MIL-G-50681D (AR)
AMENDMENT 2
09 October 1992
SUPERSEDING
AMENDMENT- 1
24 June 1991

MILITARY SPECIFICATION

GATE CIRCUIT, MULTIPLE, BOARD ASSEMBLY - LOWER: 10548550

FIGURE 5. Board Assembly - lower test setup.

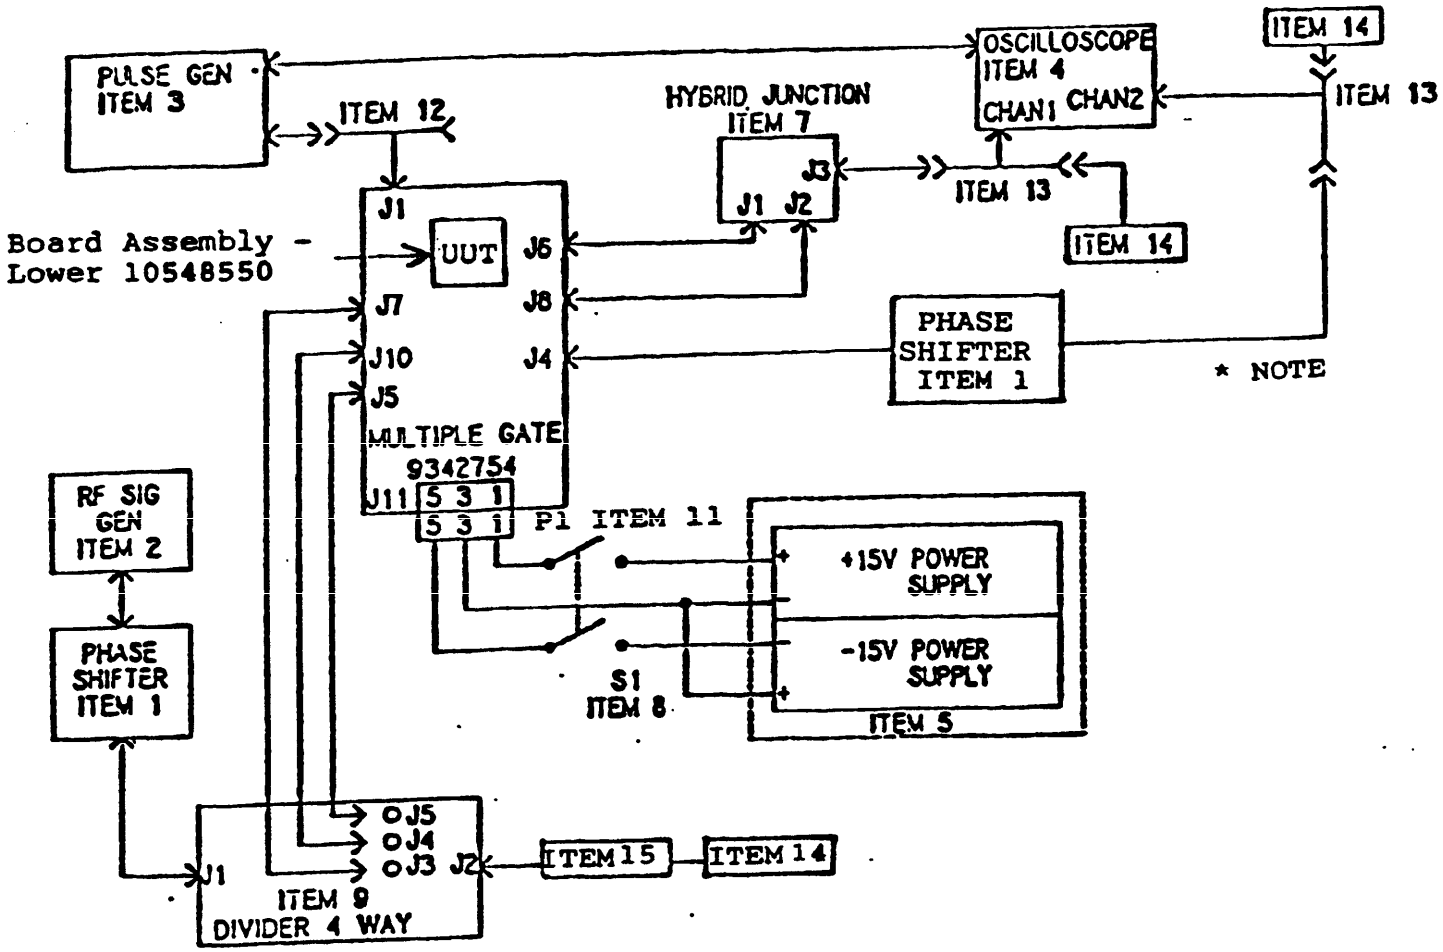
Add new paragraph 3.5.2.3.4 as follows:

"3.5.2.3.4 Gate noise. With the board assembly-lower connected with the test setup as shown in Figure 5, a 60 + 1% MHz signal and a monitored 2.8 V p-p signal per gate applied to J5, J7 and J10 of the unit under test, the amplitude of the algebraic sum of the Early Gate and Sum Gate signals during the Early Gate period shall be less than 1.0 V p-p. The amplitude of the algebraic sum of the Late Gate and inverted Sum Gate signals during the Late Gate period shall be less than 1.0 V p-p."

Add new Figure 5 as included (page 6A) .

Add new paragraph 4.7.3.4.4 as follows:

"4.7.3.4.4 Gate noise. connect the unit under test to the test setup per Figure 5. Adjust channel 2 Phase Shifter so that Early Gate on channel 1 is 180° out of phase with the Sum Gate on charnel 2. Adjust variable gain on channel 2 for equal amplitude waveform on channels 1 and 2. Place oscilloscope in charnel 1 and 2 algebraic add function and readjust channel 2 phase shifter for Early Gate null. Resultant waveforms in the Early Gate shall be less than 1.0 V p-p. Place oscilloscope channel 2 in invert mode. Readjust amplitude and phase for Late Gate null. Resultant waveforms in the Late Gate shall be less than 1.0 V p-p."

Adjust Channel 2 Cable length as necessary to place Channel 1/ Channel 2 Waveform relationship into Phase Shifter ADjustment Range.
